## Answer to Reviewer 2

After a careful homogenization effort of the OHP ozonesonde record, as described in Ancellet et al. (2022), the OHP team proposes an additional correction for anomalous low ozone records in the 2002-2007 time period. As those low ozone partial pressures in this period coincide with low internal pump temperatures during this period, a correction method that linearly increases the pump temperatures with height is proposed. This method is then evaluated making use of co-located lidar and MLS overpass stratospheric ozone profile measurements and of the total column ozone amounts retrieved from a collocated SAOZ instrument.

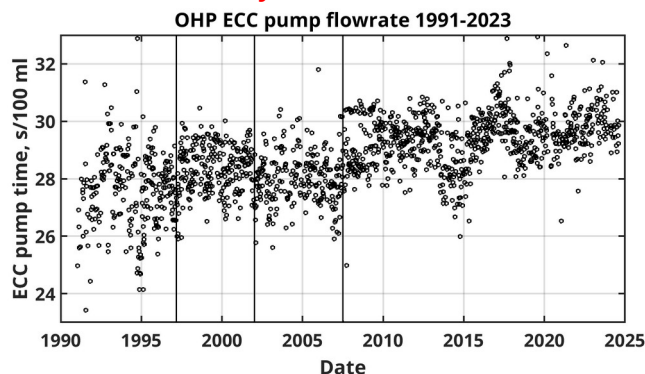
*The authors therefore could/should analyze their metadata records and try to determine any coincidences with the beginning and end of the 2002-2007 period. In this respect, it would also be very helpful to provide some additional plots:*

*- The ozonesonde serial numbers versus time*

The serial number of the ECC sondes used in 2002-2007 did not correspond to known problems in the production of ENSCI ozonesonde. A new paragraph to discuss this point is added in section 4.1 line 121-125 with a reference to Stauffer et al. 2022:

« Stauffer et al. (2022) reported that ENSCI ECC total ozone column drop occurring at selected sites after 2013 could be related to ozonesonde production changes as well as station-specific factors due to ozonesonde preparation. ECC serial number are above 20000 for the sounding with TCO drop larger than 3-5%. The ENSCI serial number are between 6200 and 12800 for the OHP sounding made between January 2002 and June 2007. We therefore cannot identify a clear connection with the sonde production quality discussed in that paper. »

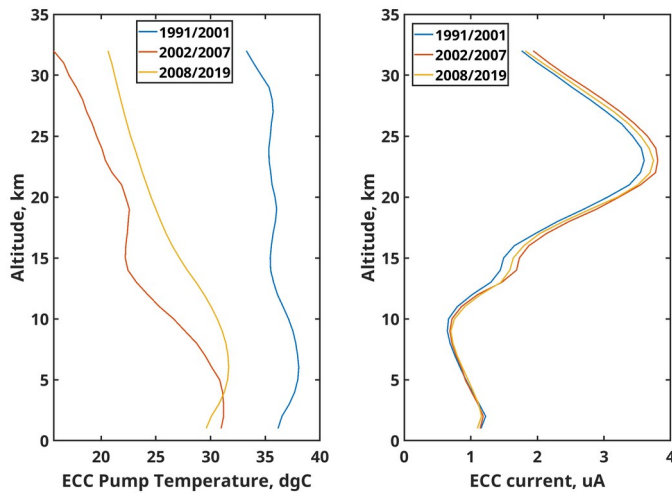
- The mean vertical profile of both the measured and O3S-DQA corrected (see Ancellet et al., 2022 and my point 4) internal pump temperatures for the three periods. This information is to some extent provided in Fig. 3 (is it the measured or corrected internal pump temperature?), but I guess that a mean vertical temperature profile would give more information if the anomalous low temperatures in period 2 are arising at all vertical levels or from some typical altitudes onwards. Of course, period 3 might be further split in subperiods, so that the number of years for each period does not differ too much.

2. In addition to the direct (mathematical) impact of lower pump temperatures on the ozone partial pressure values through Eq. (1), there is also an indirect impact. As the ECC cell temperatures are typically around 5 to 10 °C lower than the measured pump temperatures (with the 5°C more typical for SPC ozonesondes, and the 10°C applying for En-Sci ozonesondes), as measured in simulation chamber tests with ozonesondes, the lower pump temperatures in the 2002-2007 period might be associated with ozonesonde cells with frozen solutions (cell temperature close to 0°C). In such cases, the chemical reactions inside the cells will be less efficient or slow down, and as a consequence much lower currents will be generated. In the Uccle station, I could identify this feature quite regularly in the upper parts of the ozone profile when the En-Sci ECC (measured) pump temperatures drop to below 10°C or lower (despite active heating). However, at OHP, from your table 1 and Fig. 4, it seems that during the anomalous period 2 (2002-2007), higher cell currents are measured at 25 km compared to the periods before and thereafter. I found this rather surprising and this argues against the hypothesis of frozen solutions during this period 2. Can you therefore more extend on this analysis and also look at e.g. other altitude levels? It would also be interesting to produce some mean vertical profiles of pump temperature, ozone partial pressure, and cell current for (the) different periods to analyze in greater detail the hypothesis of frozen solutions (relation between pump temperature close to 10°C from given altitudes & cell current and/or ozone partial pressure drops from that given altitude as well?).

We agree with the reviewer that the submitted version does not provide sufficient information on the mean vertical distribution of ECC temperature and current, beyond what is shown in Figure 4. The temperature of the pump  $T_p$  is always the homogenized temperature in the paper (this point has been clarified throughout the text, and we apologize for not having made it clear earlier see answer to point 4).

A new figure 5 added to the paper shows the mean vertical distribution and lines 141-148 discuss the possible interpretation of this figure:

« First, the mean vertical distribution of the homogenized ECC temperature and of the ECC current for three periods (1991- 2001, 2002-2007, 2008-2019) are shown in Fig. 5 to emphasize that the ECC temperature drop in 2002-2007 increases with altitude in the stratosphere as does the difference between internal and external ECC pump temperature shown in the analysis of Smit et al. (2012). The differences of ECC current between 2002-2007 and 1991-2001 does not show a clear altitude dependency with no evidence of lower current difference at 30 km than at 20 km in 2002-2007 as we might expect if the ECC solution temperature is so cold that it becomes frozen. In fact the relative differences of ECC current between 2002-2007 and 1991-2001 are however -5.4% at 20 km, -5.7% at 25 km and -6.8% at 30 km. Wrong values of the recorded ECC pump temperature in 2002-2007 would thus remain as the possible primary cause of the negative ECC ozone concentration bias at 25 km. »

In Fig. 5 the period 3 and 1 have now the same duration (10 years) but this does not change the values used in tables 1 and 2. A period long enough for the reference values before 2002 and after 2007 are necessary considering the limited number of sonde launched per month (of the order of 4).

That's a very interesting point raising the possible indirect effect of frozen solutions. It is addressed in the answer to point 1 and especially by showing the mean vertical profile of the ECC current in Fig. 5. Indeed we would expect faster decrease of the ECC current in 2002-2007 than for the periods where we do not suspect the solution to be frozen. So we believe fig.5 and the discussion line 141-148 answer the questions raised by the reviewer.
